PLANNING COMMITTEE – 24 JULY 2018

Application No:	18/00125/FULM (MAJOR)	
Proposal:	Proposed conversion of Hatton House (formerly Newark Working Men’s Club) Beacon Hill Road Newark, to form 8 apartments. Remainder of building to be demolished. To include erection of 8 new cottages and associated access and landscaping works.	
Location:	Newark Working Men’s Club, 13 Beacon Hill Road, Newark On Trent	
Applicant:	Northgate Lettings	
Registered:	31 January 2018	Target Date: 01 May 2018

UPDATE

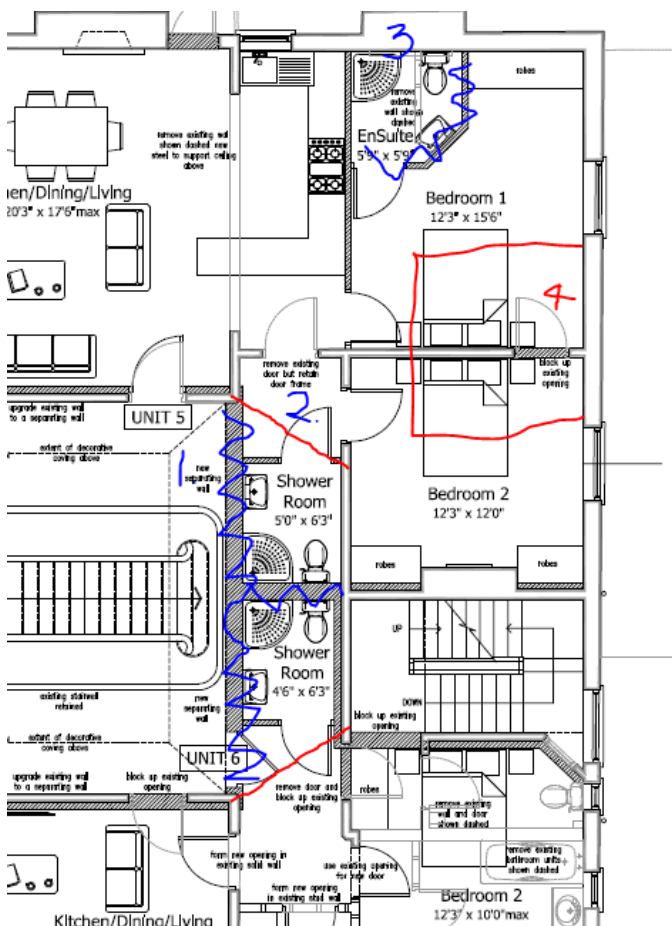
The main alteration here is the reinstatement of the grand, staircase down from the first floor level. This will be a significant heritage gain and improvement to the aesthetic significance of the building as well as making the plan form more legible. I understand new decorative metal stair rods would be cast to match, though this detail should be conditioned. Now that the suspended ceiling over the bar has been removed the decorative coving is now revealed and while it will **need repair (to be conditioned)** it is relatively well preserved and mostly capable of repair. **The treatment of the tiles in the hallway, as well as the spec for coving repair, should also be conditioned.** This should secure a significant heritage gain for this building.

In order to divide off the separate residential units from this communal hallway I appreciate that a new inner hall is to be created, to allow not just access into the flats but access *within* the flats to different rooms. This seems like an acceptable compromise and the original hallway will still be retained in plan but **the retention of a downstand** where historic walls are being widened out should be conditioned, as this will make the plan form more legible. I understand the **new inner hall can sit just within (and therefore not harm) the moulding on the hallway ceiling, but again this detail could be secured by condition.**

The front rooms are the only rooms which retain their original proportions, though with no fireplace or chimney breast. While the left hand room will be partially opened up to create a kitchen/diner the original layout can be read by conditioning a downstand, and is a 'trade-off' for the re-formation of the right hand room.

The removal of the rear extension gives the opportunity to re-form the original position of the back wall. While these back rooms are to be then subdivided they have long since lost any significance by the wholesale opening up which occurred in the 1960s/70s, so I have no objection to their subdivision and think there is still overall heritage gain by re-forming the original position of the back wall.

Please see my annotated floor plan for suggested amendments to the first floor:

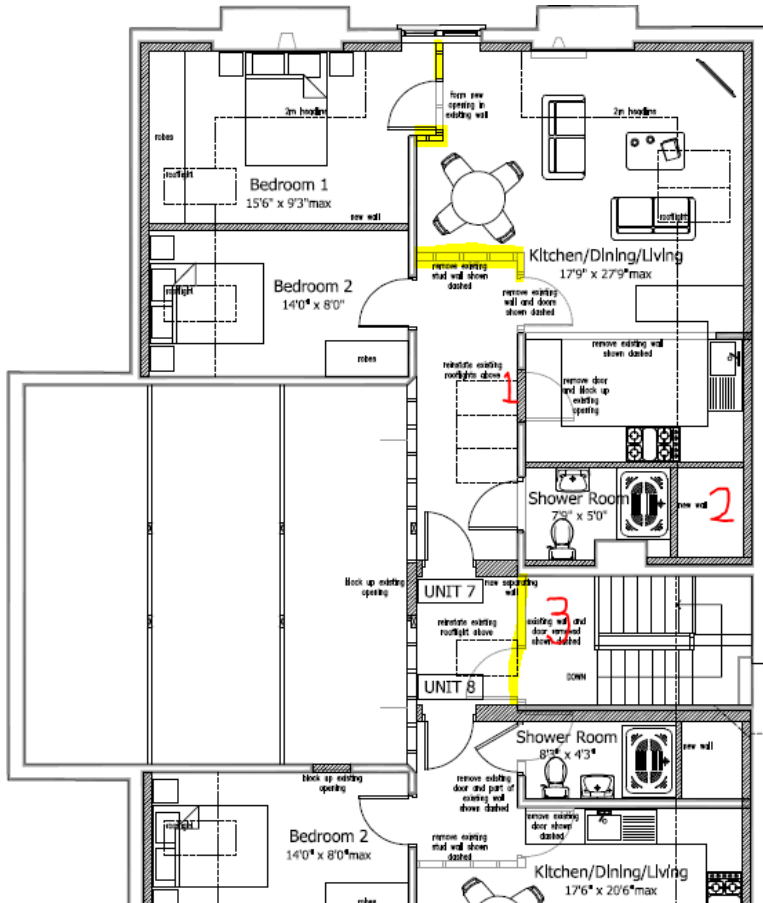
My main issue with this first floor layout is the way the reinstatement of the grand staircase will be compromised by bringing forward rooms right up the banister, removing the landing, as marked with the blue zigzag line and number 1. This will crowd the staircase and undermine the ostentatious sense of space (and circulation) that it was designed to bring. I have spoken to the owner about this specifically and accept there needs to be some form of easement to keep access across the landing it the flats, but that this can be achieved by a chamfered corner, as marked

number 2 above, leaving most of the original landing open. This will complete the positive impact of reinstating the grand staircase.

I am also not happy at the proposed ensuite across a fireplace (marked number 3 above). I do appreciate an existing inappropriate stud wall here, but the removal of this and reinstatement of the fireplace as a proper feature will be a positive enhancement which could be achieved here. The compromise is the need to achieve bathroom space and I feel this is best achieved by creating a 'Jack and Jill' style arrangement as marked number 4 above. Overall, I think this will be a better arrangement than is currently at the building and a reasonable compromise moving forward. What we didn't discuss on site, but which could be looked at, is whether the floor to ceiling height is such that this ensuite could be formed more as a pod, sitting under the original ceiling height allowing the original layout of the room to be read. The other option, which was used at St Pancras Station Hotel and put forward in the recent Kelham Hall application, is to create a bespoke bed which has an ensuite behind, almost like a fitted wardrobe, although I appreciate this may be more appropriate for hotels than for residential properties.
